INDIANA DEPARTMENT OF TRANSPORTATION

APPROVED MINUTES

December 17, 2020 Standards Committee Meeting

RE: Minutes from the December 17, 2020 Standards Committee Meeting

E 509-CCJR-02 LONGITUDINAL JOINT REPAIR, PARTIAL DEPTH (proposed new)

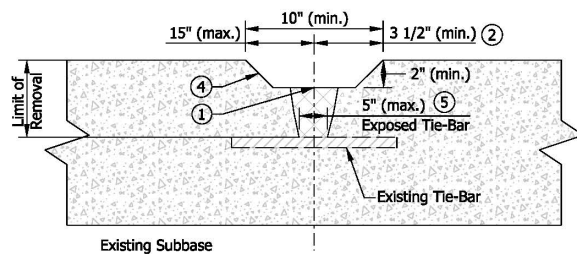
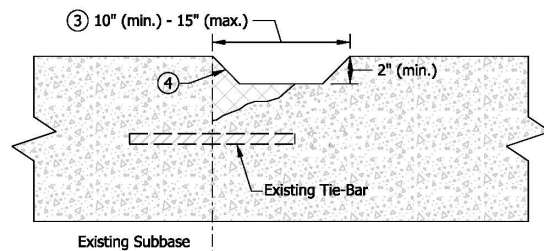
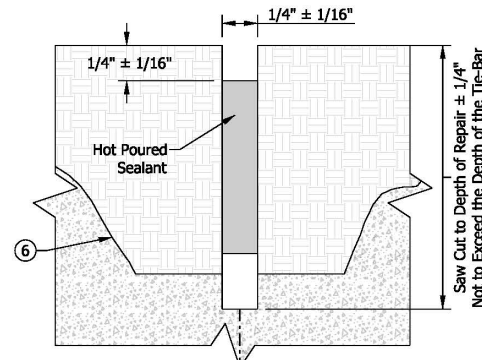
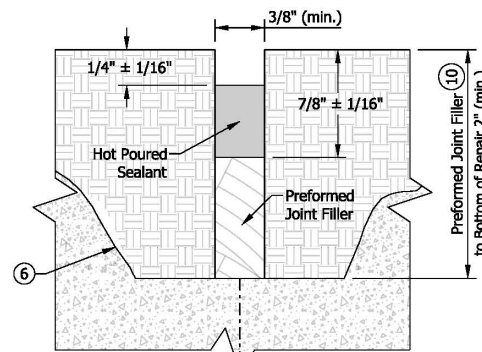
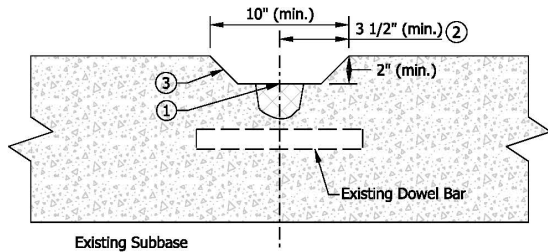
Minor revisions are as shown resulting from other brief discussions. Further discussion ensued concerning drawing details involving the removal details.

- ⑥ 2 in. minimum milling shown, additional hand chipping may be required to remove unsound concrete.
7. Existing tie-bars exposed after removal shall be removed to the face of existing concrete. For tie-bar tolerance, see Standard Drawing Series E 503-CCPJ.

E 724-BSSJ-08 EXPANSION JOINTS CLASS SS (WITH MARKUPS)

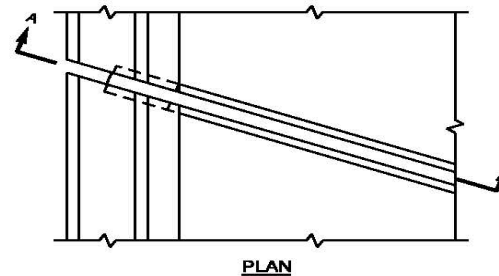
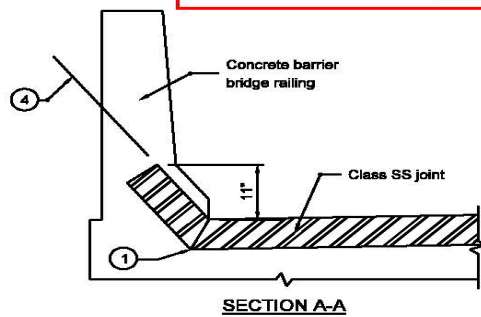
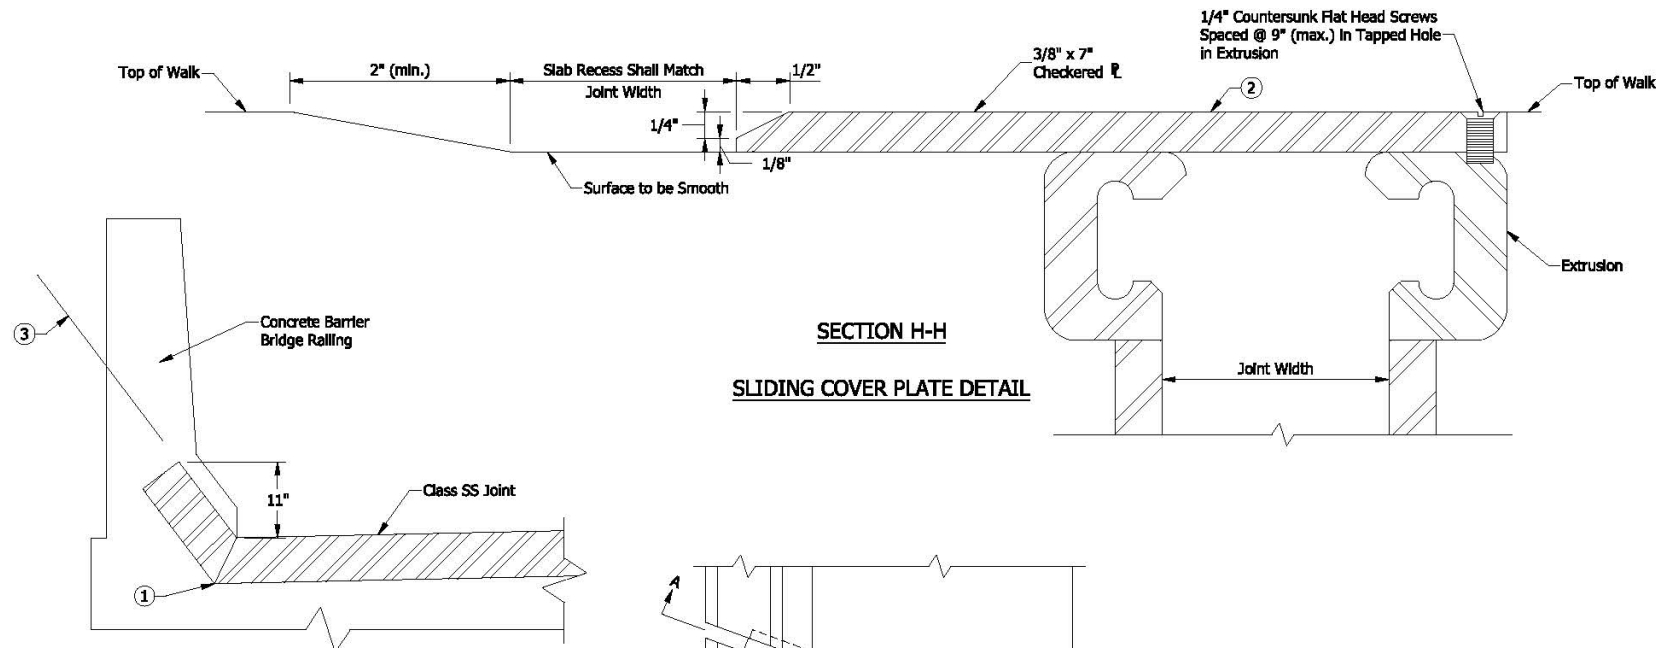
PROBLEM(S) ENCOUNTERED: Standard Drawing E 724-BSSJ-08 shows a sliding cover plate detail that is used to bridge the gap between type SS expansion joint extrusions when the joint is located in a sidewalk. The slide plate is 3/8 in. thick and a recess of the same thickness is formed in the sidewalk adjacent to the slide plate. Current ADA requirements limit vertical changes to 1/4 in., and changes up to 1/2 in. need to include a bevel with a 2h:1v or flatter slope.

The current detail shows the 3/8" thick slide plate and the 3/8" deep recess with square edges. Current ADA requirements indicate that the maximum allowable vertical height difference is 1/4", and larger height differences should be transitioned at a 2h:1v slope. Therefore, the slide plate detail will be updated.

This item was introduced and presented by Mr. White, sitting in for Mr. Orton, who stated that Standard Drawing E 724-BSSJ-08 shows a sliding cover plate detail that is used to bridge the gap between type SS expansion joint extrusions when the joint is located in a sidewalk. The slide plate is 3/8 in. thick and a recess of the same thickness is formed in the sidewalk adjacent to the slide plate. Current ADA requirements limit vertical changes to 1/4 in., and changes up to 1/2 in. need to include a bevel with a 2h:1v or flatter slope.

PROPOSED SOLUTION: The sliding cover plate detail will be revised to include a 2h:1v bevel on the leading edge of the steel sliding plate, and the recess will be transitioned at a slope flatter than 2h:1v.

Mr. White proposed that the sliding cover plate detail will be revised to include a 2h:1v bevel on the leading edge of the steel sliding plate, and the recess will be transitioned at a slope flatter than 2h:1v, as illustrated above.
